**SOIL/SITE EVALUATION
 for ON-SITE WASTEWATER SYSTEM**

Handwritten notes:
 Permit copy
 1" = 40'
 "The charrested"
 Lot # 1 Hilland Forest
 DTR, LLC

Show profile locations and other site features (dimensions, reference or benchmark, and North).

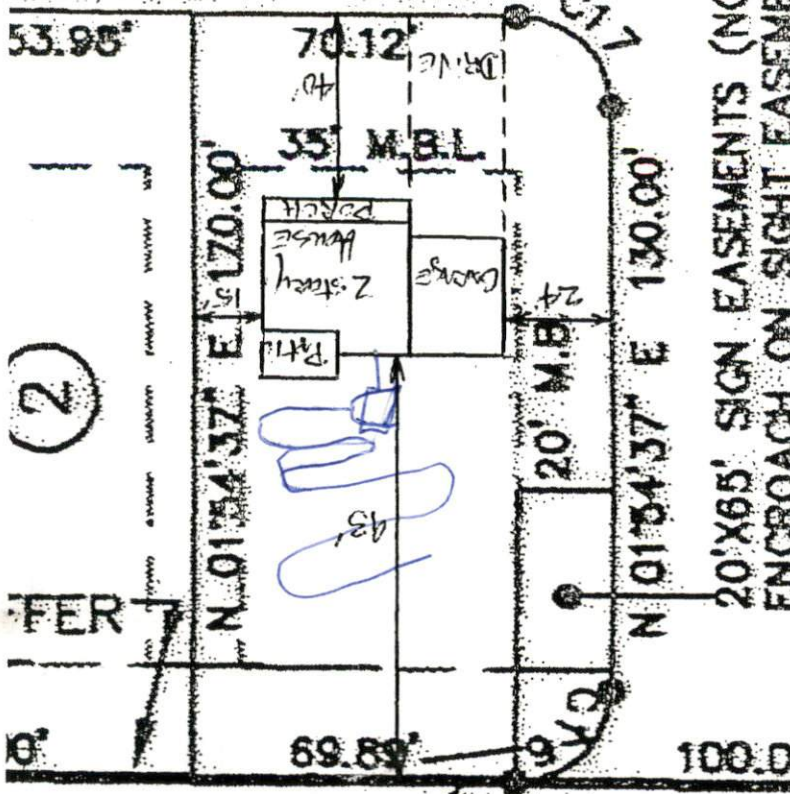
Change to 25% sub. To save space

Handwritten notes:
 17x150
 18-24
 25% Rd
